**Subject: Responses to Comments to Request for Approval of Design Exception
CSSFT-0008-00(314) Pickens County
P.I. Number: 0008314
SR 136 from SR 136 Connector to SR 515
GS&P Project No. 24643.05**

Subject: Revised Request for Approval of Design Exception
CSSFT-0008-00(314) Pickens County
P.I. Number: 0008314
SR 136 from SR 136 Connector to SR 515
GS&P Project No. 24643.05

**SR 136 from SR 136 Connector to SR 515
Safety Improvement Project**
CSSFT-0008-00(314) P.I. Number: 0008314

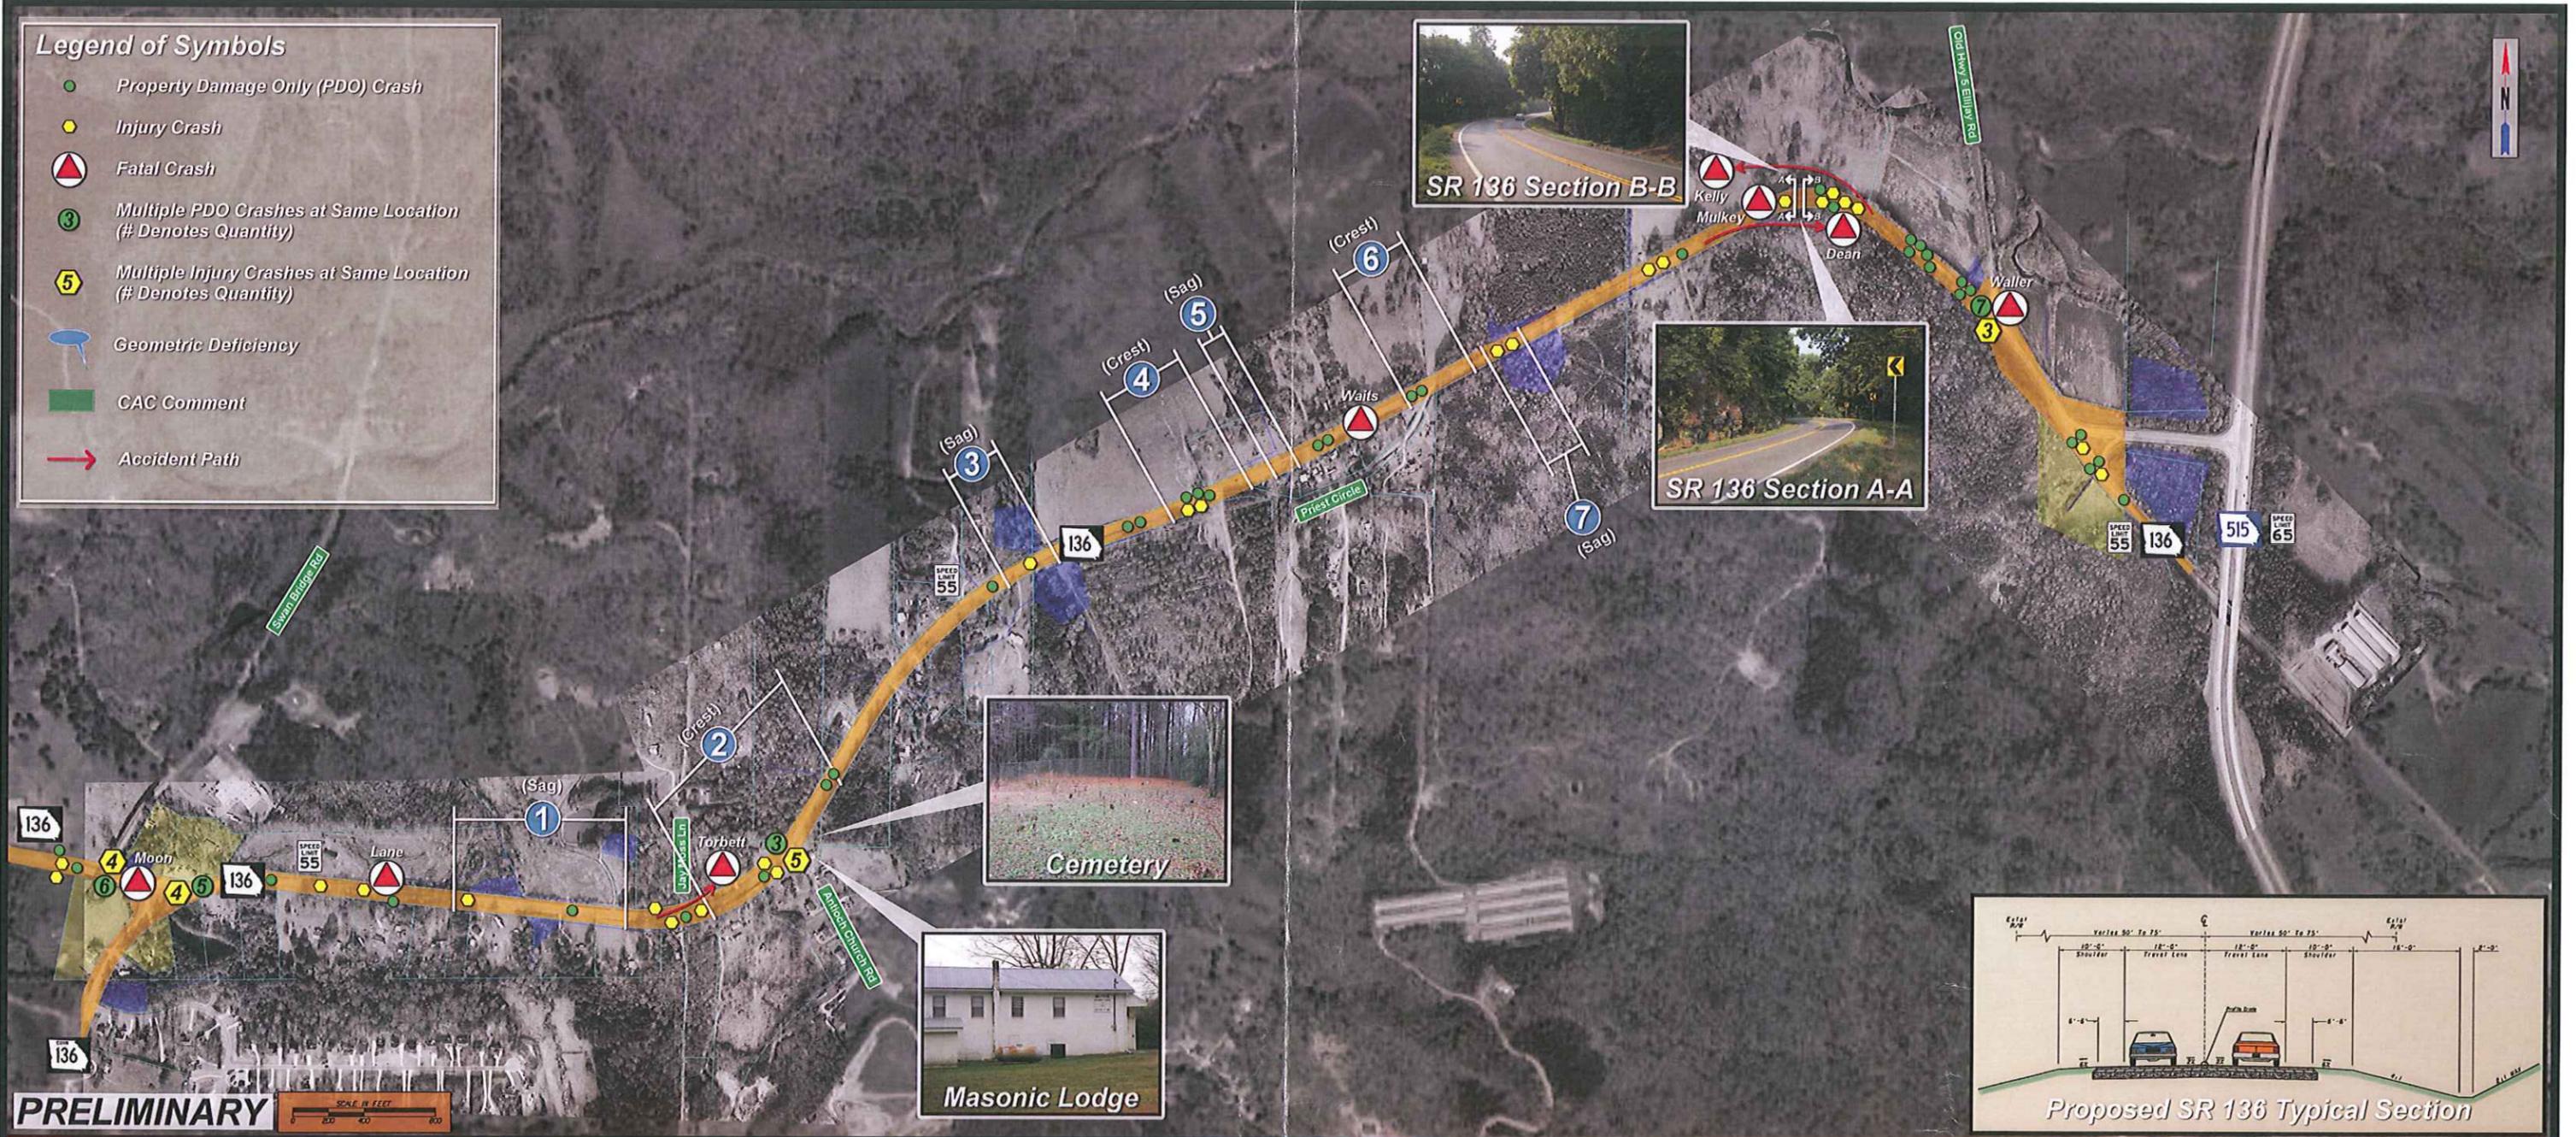
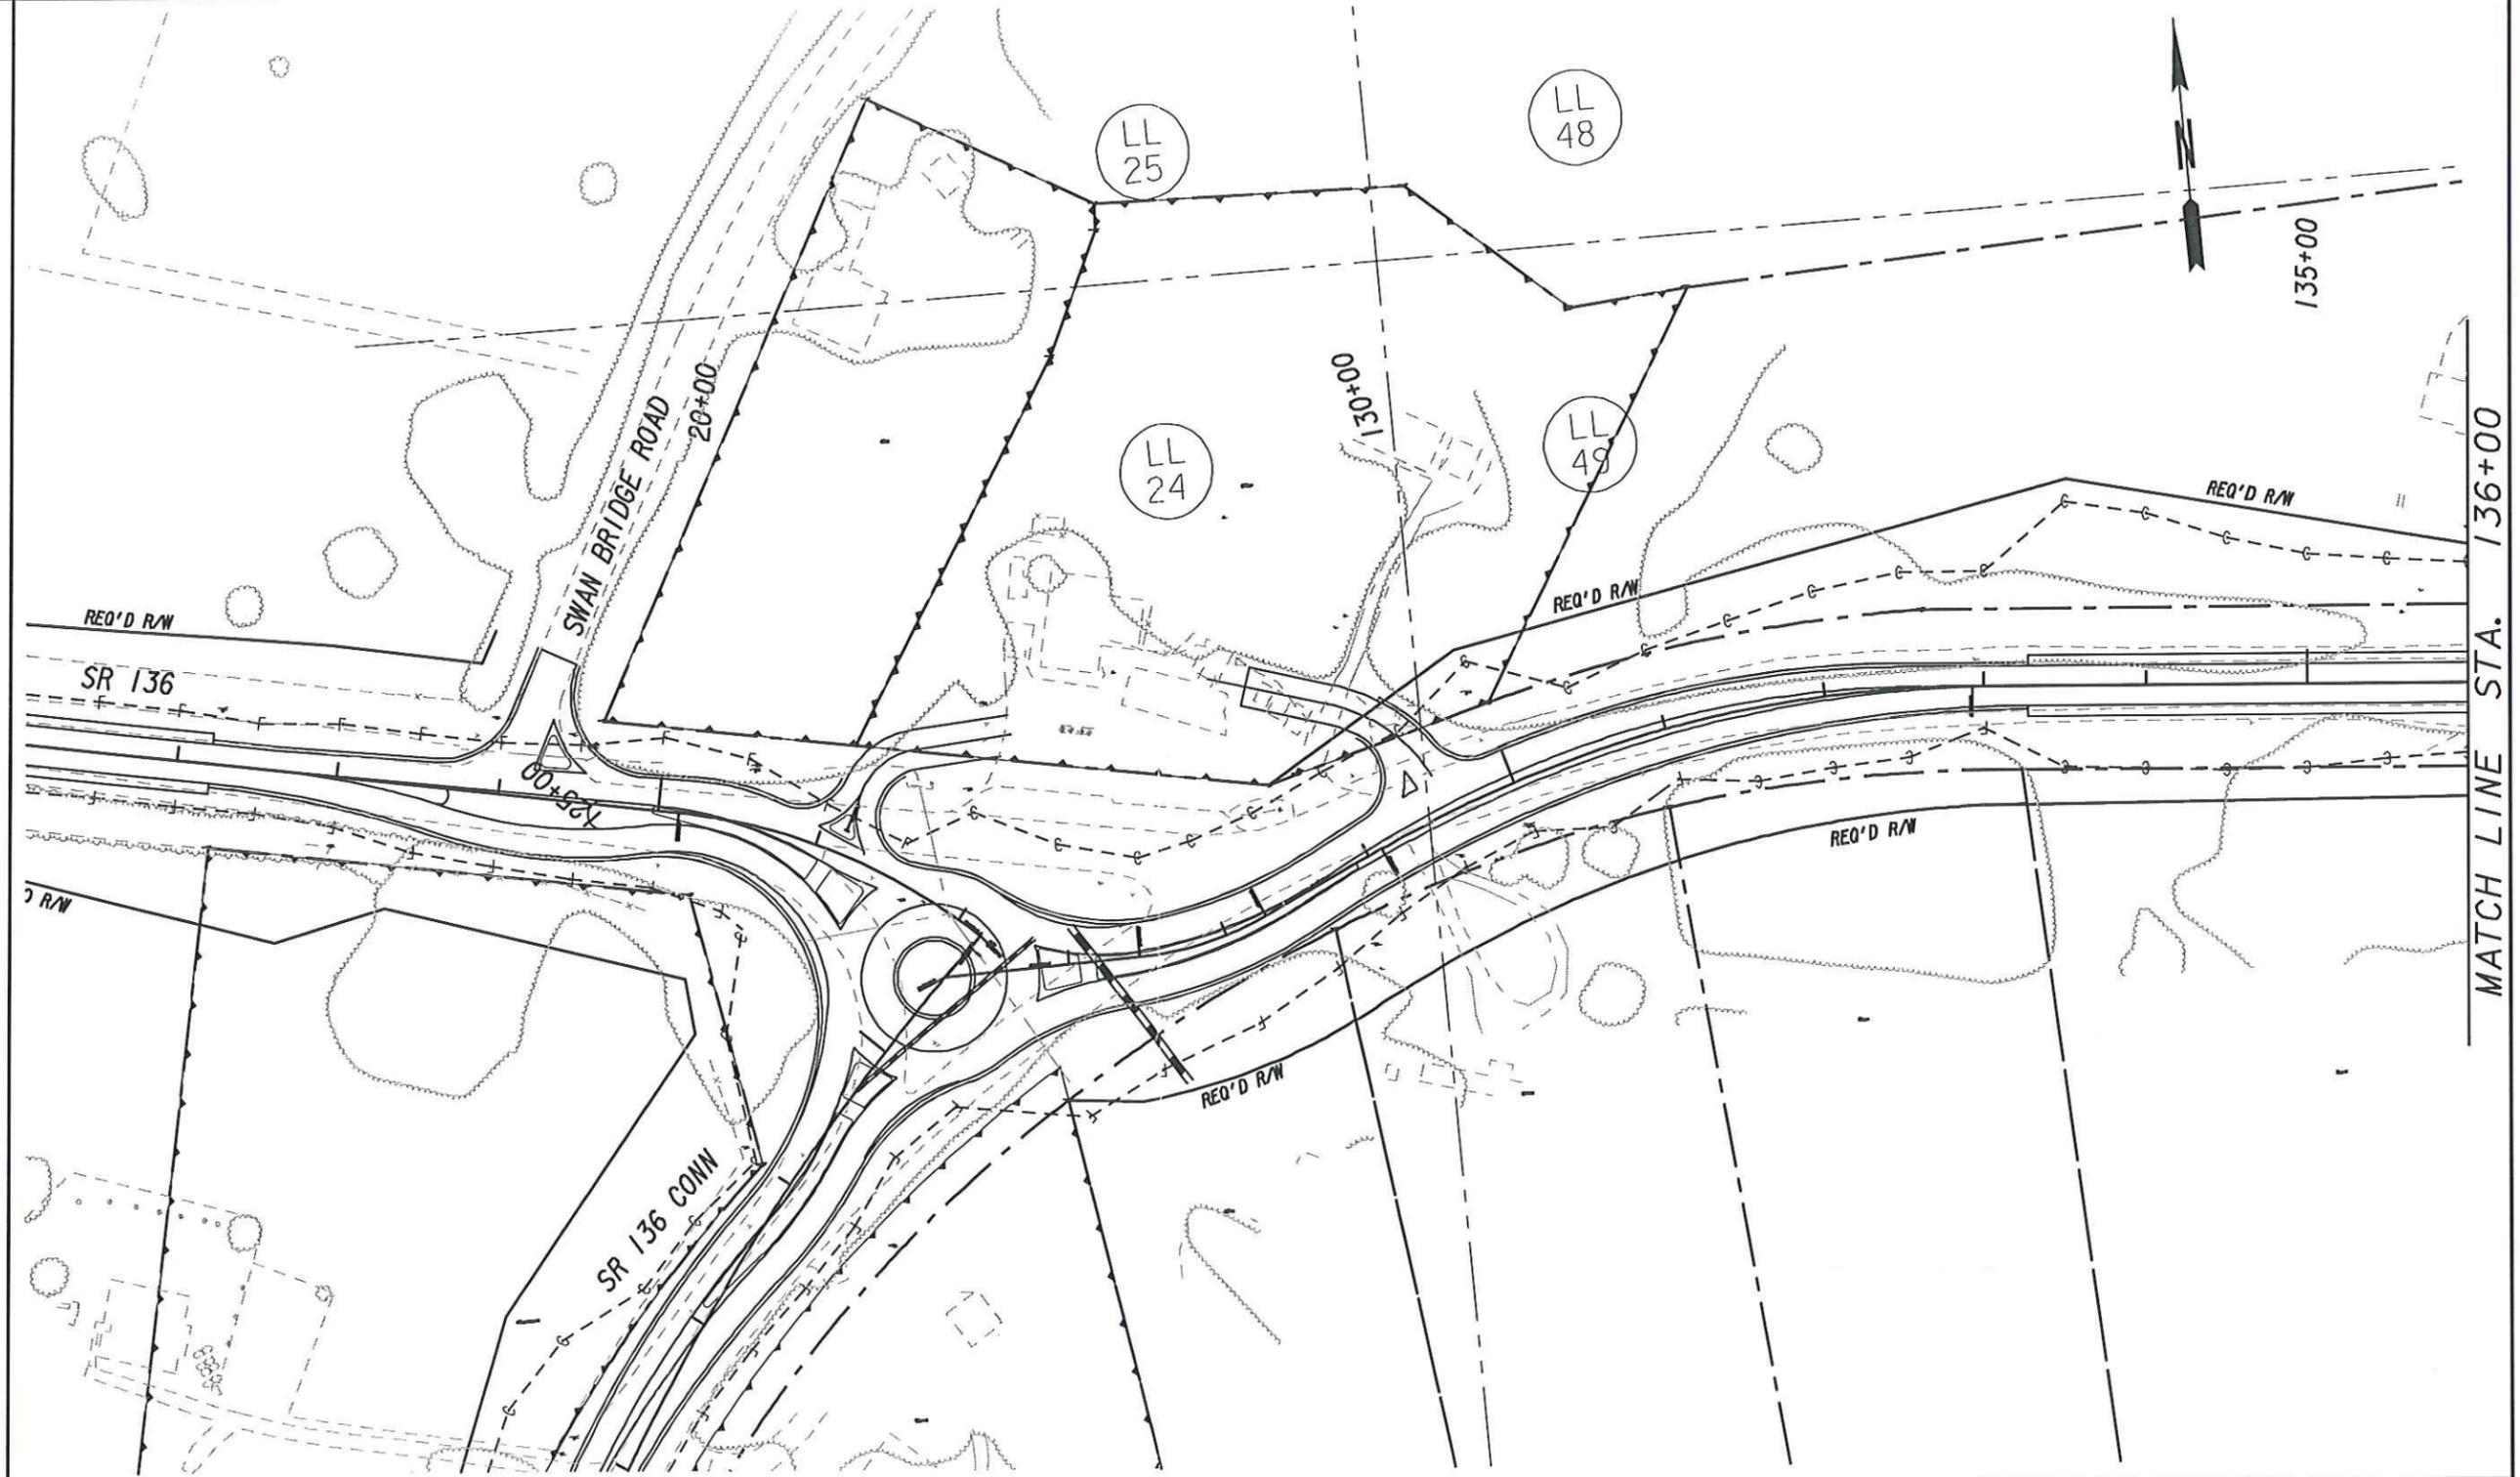
- 5. In the Recommendations section it is concluded that an adjusted profile per AASHTO guidance would have little to no potential in reducing crashes or frequency of crashes. Please provide explanation and supporting documentation for the noted conclusion.*

- 6. The proposed project layout provided on the last page of the design exception request supplements the crash data (Table 1) by providing the location of the fatalities that occurred along the project corridor. Please also provide information on the time of day and type of crash that resulted in injury and/or fatality for the locations identified.*

This discussion has been removed from the revised request. A drawing has been included that conveys the seven vertical alignment areas and the documented crashes in each area.

Attached to this request is a drawing showing the seven vertical alignment areas described above. Each area has been identified and located in proximity to the documented crashes during the study period.

STATE OF GEORGIA
DEPARTMENT OF TRANSPORTATION
OFFICE: PROGRAM DELIVERY
MAINLINE PLAN
PROJECT: CSSFT-0008-00(314)
COUNTY: PICKENS
DRAWING No. 13-01

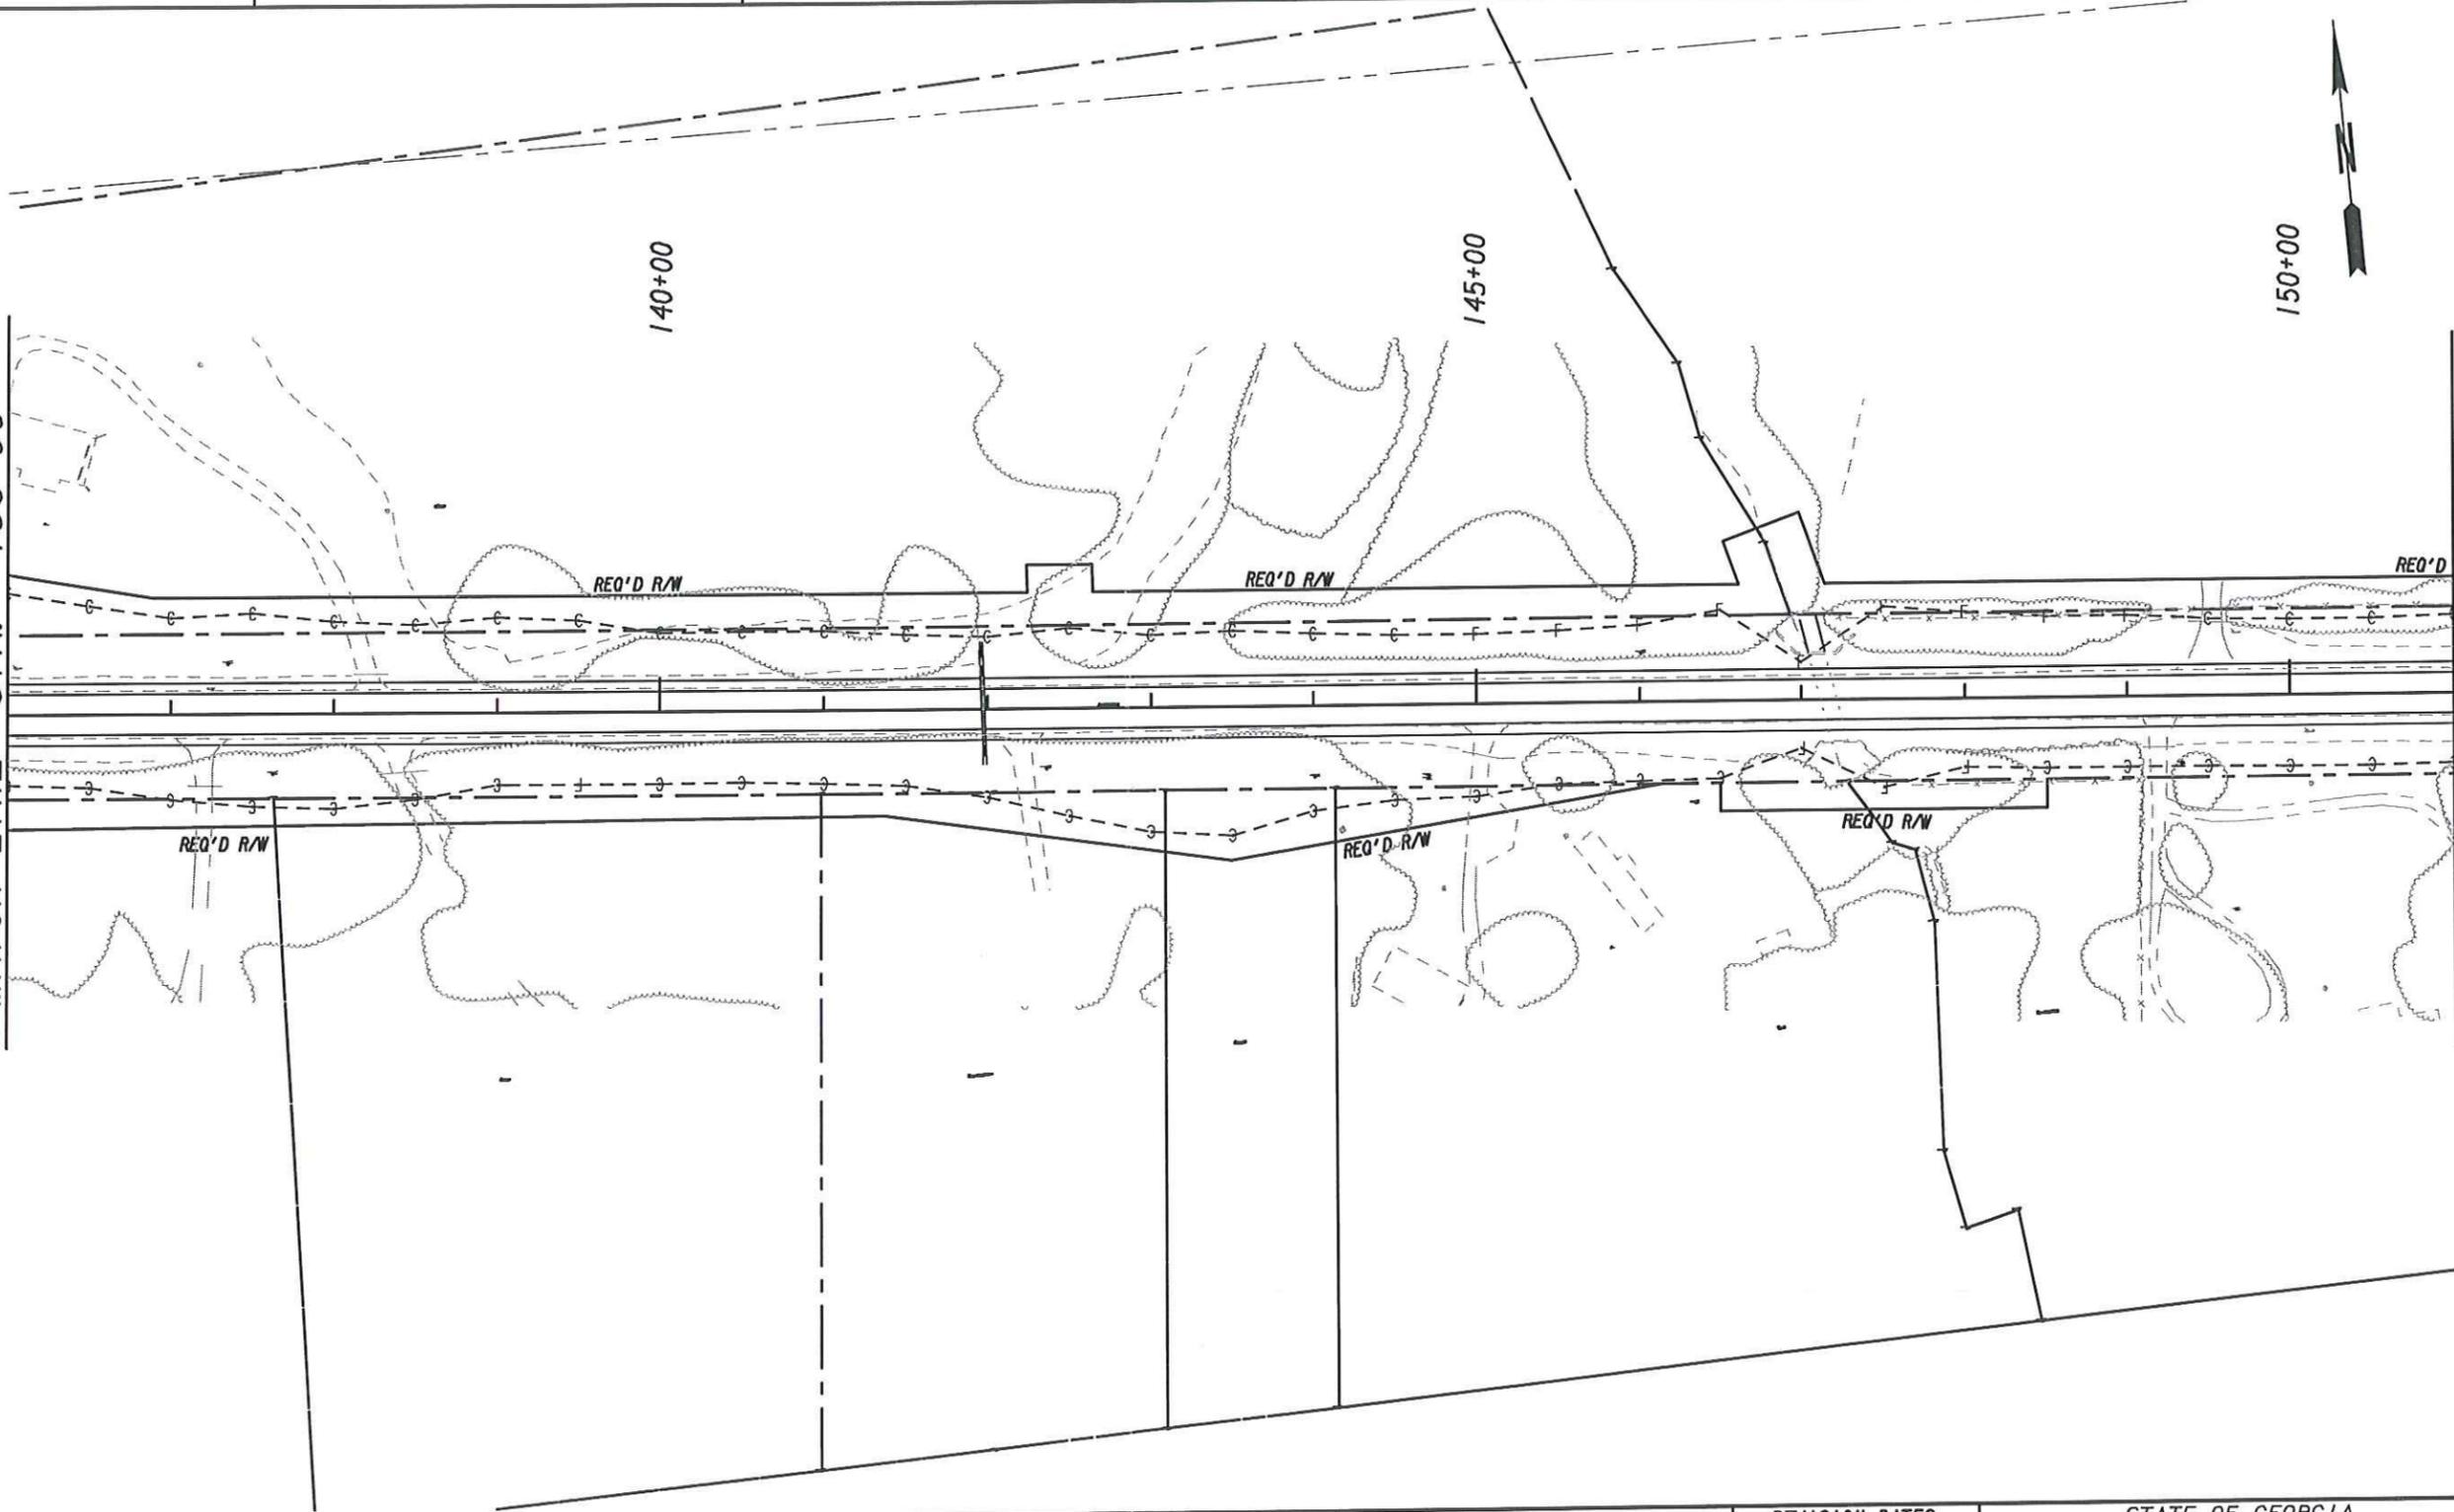
- 8. Page 13-01, the drive located near STA 130+00 seems to present the opportunity to cause adverse impact to the roundabout intersection located west of the location. As shown on the*

construction layout, the permissible left turn movement by eastbound drivers can influence the free flow operations of the roundabout. Furthermore, the left turning movement at the noted location could also increase the occurrence of rear-end crashes. Please ensure that the proposed design provides adequate operations throughout.

This suggestion will be considered during the design phase of the project, however is unrelated to the design exception being requested, and therefore has not been included in the revised request.
